**Zoning Ordinance Approval
CITY OF AUSTIN
RECOMMENDATION FOR COUNCIL ACTION**

SUBJECT: C814-90-0003.13 - Harris Branch PUD Amendment #13 - Approve second/third readings of an ordinance amending Chapter 25-2 of the Austin City Code by rezoning property located at 1375 U.S. Highway 290 East at Proposed State Highway 130 (Harris Branch, Gilleland Creek, Decker Creek Watersheds) from planned unit development (PUD) district zoning to planned unit development (PUD) district zoning to change a condition of zoning. First reading approved on October 27, 2005. Vote: 6-0, Council Member Alvarez off the dais. Applicant: Austin HB Residential Properties (John McCullough). Agent: Minter, Joseph & Thornhill, P.C. (John M. Joseph). City Staff: Sherri Sirwaitis, 974-3057.

ZONING CHANGE REVIEW SHEET

Current Approved Harris Branch PUD Land Use Plan

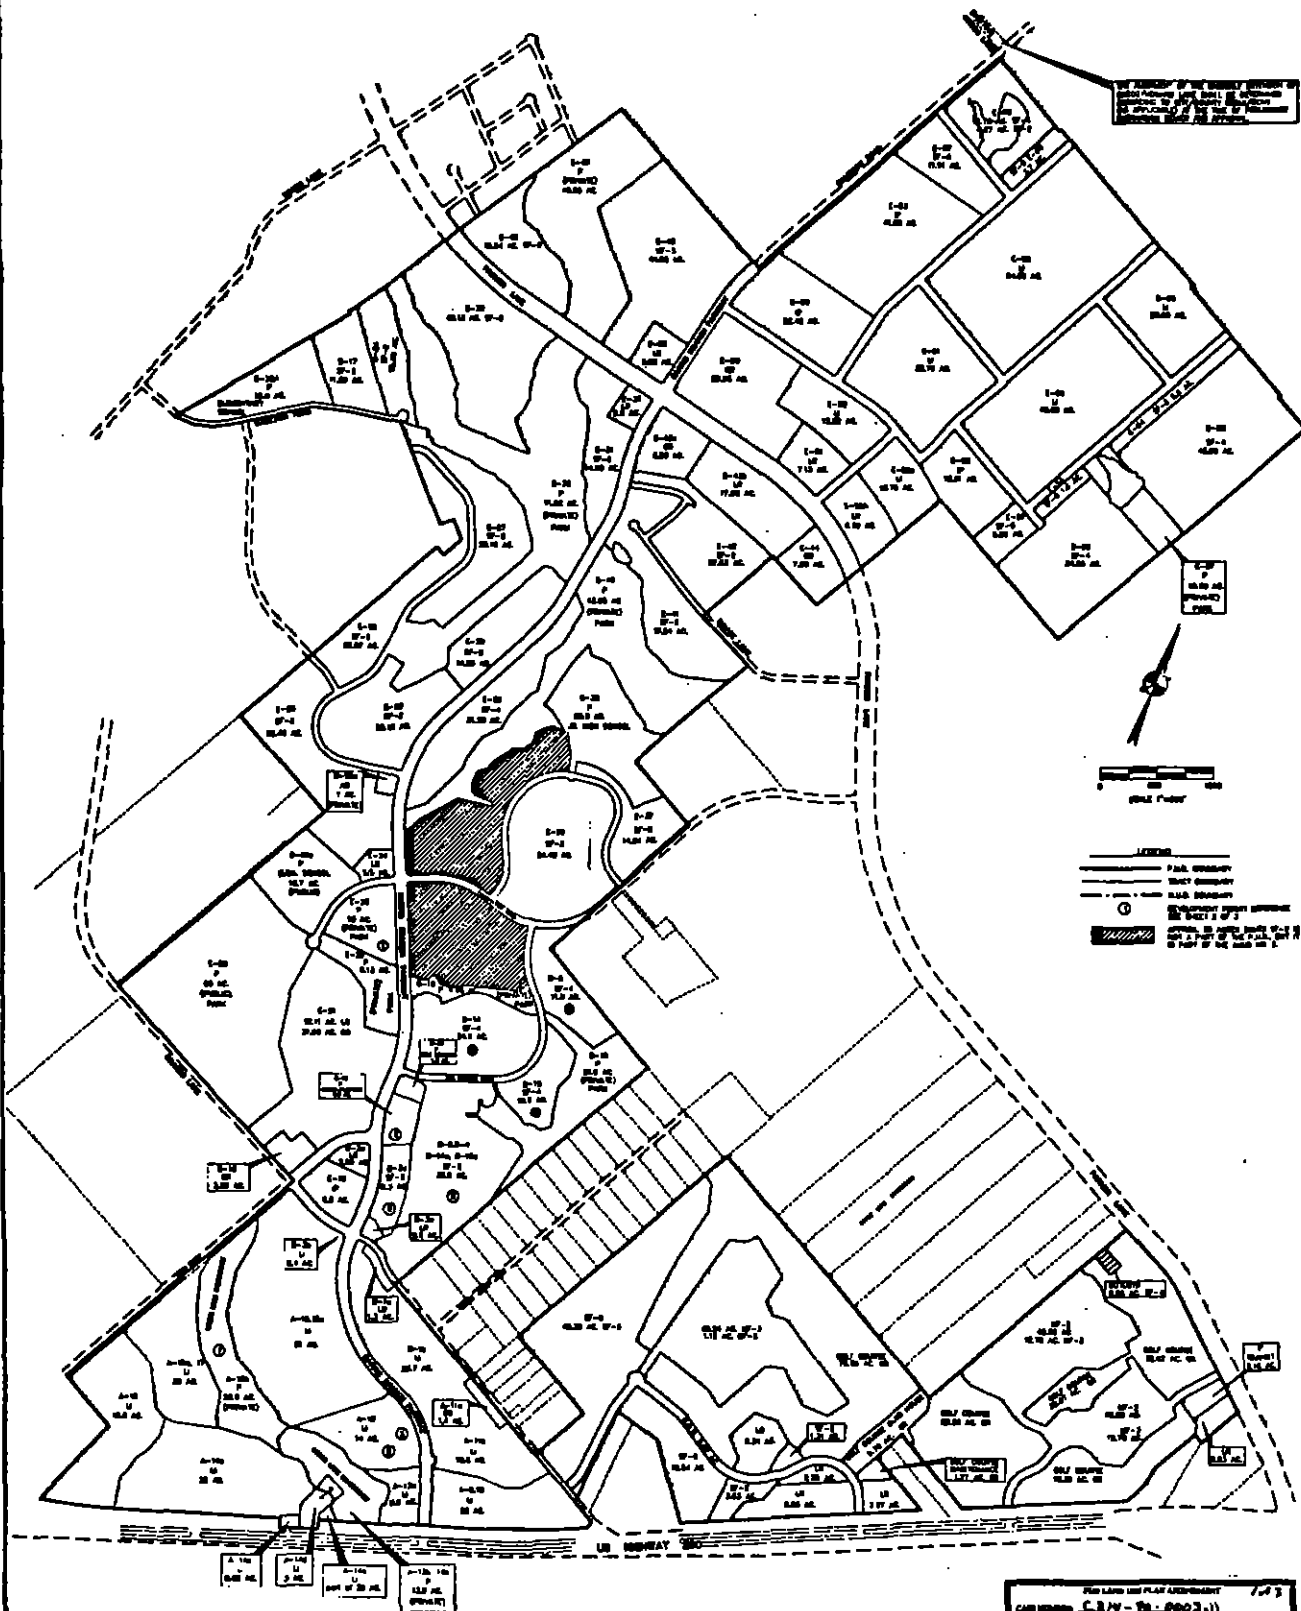
It is difficult to tell on sheet 2 of the PUD plan what has changed, since Revision 13 is with 11 & 12, and the changes were not clouded.

Please redline the approved Harris Branch PUD Land Use Plan to directly show the proposed changes for the PUD. Please redline the PUD Densities Tables - Sheet 2 to display how the proposed revisions to Tracts SG-1 through SG-14 will affect the breakdown of uses and within the PUD. Please provide information concerning the how the proposed land use changes will affect the overall building coverage and impervious cover amounts within the PUD.

ZN-2 The Harris Branch PUD Land Use Plan has a "red line" drawn around the areas subject to this amendment. Attached Please see the revised Harris Branch Density Tables – Sheet 2 showing the effect on building coverage and impervious cover.
